No.2019/M(N)/204/6 (E-3324111)

Sub: Maintenance of 'E' dimension of Slack adjuster in Freight stock.

No. MW.ABP

Sub: - Maintenance of 'e' dimension in wagon.

Annexure-II A

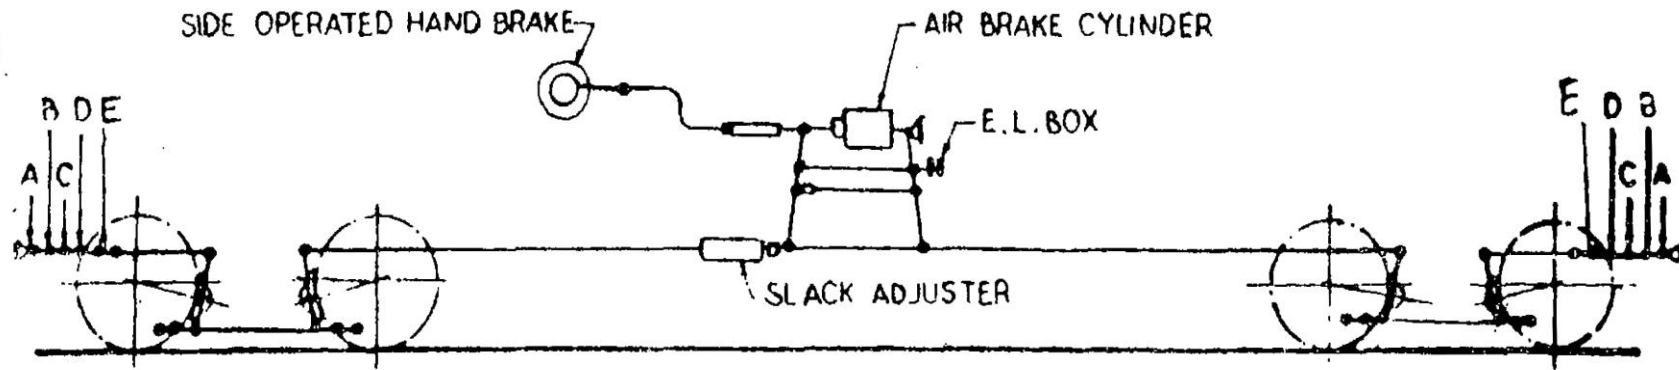
- c. Adjustment of bogie end pull rod and push rod is governed from the following:
 - 1) With new wheel i.e. full diameter, bogie end pull rod shall be on outer most hole and bogie push rod shall be on inner hole.

- 2) With wheel wear, first adjustment shall be done on bogie end pull rod towards inner holes. When entire adjustment capacity of end pull rod is exhausted then bogie push rod shall be adjusted to outer holes. With shifting the push rod to outer holes, the angularity of vertical equalising lever will be corrected.

- 3) Schematic diagrams for clarity are attached as **Annexure-II A & II B**.

Manual Adjustment of Bogie brake gear on wagons fitted with LWLH 25T Bogies

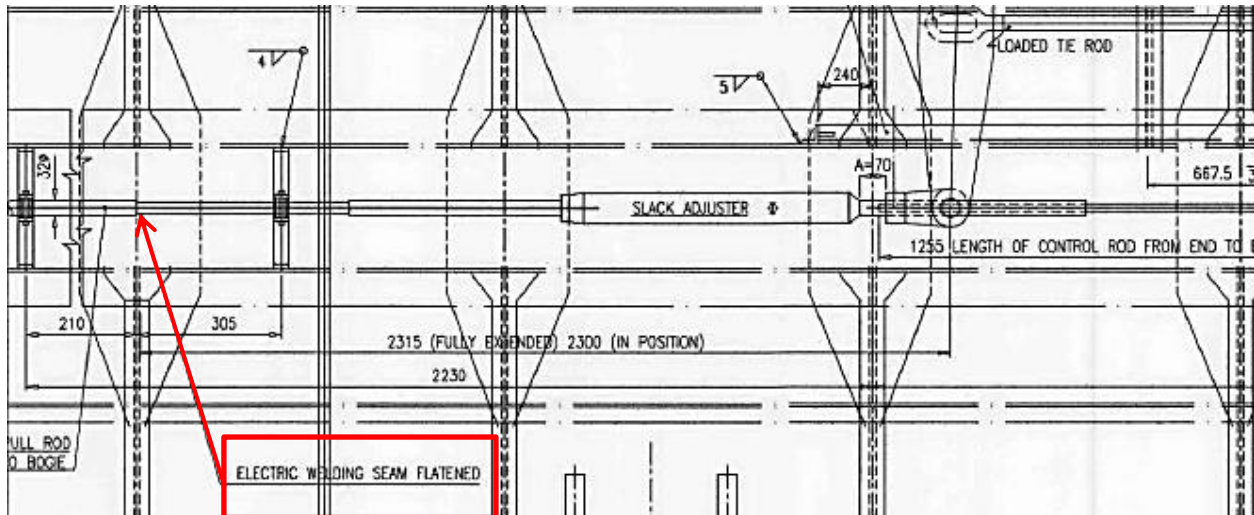
THE ADJUSTMENT OF BRAKE GEAR PINS SHOULD BE MADE DURING THE CHANGE OF BRAKE BLOCKS & AS WHEEL WEARS, SO THAT THE EQUALIZING LEVER REMAINS IN VERTICAL POSITION. IN THIS REGARD THE HOLES PROVIDED IN THE PUSH ROD CAN ALSO BE MADE USE OF.
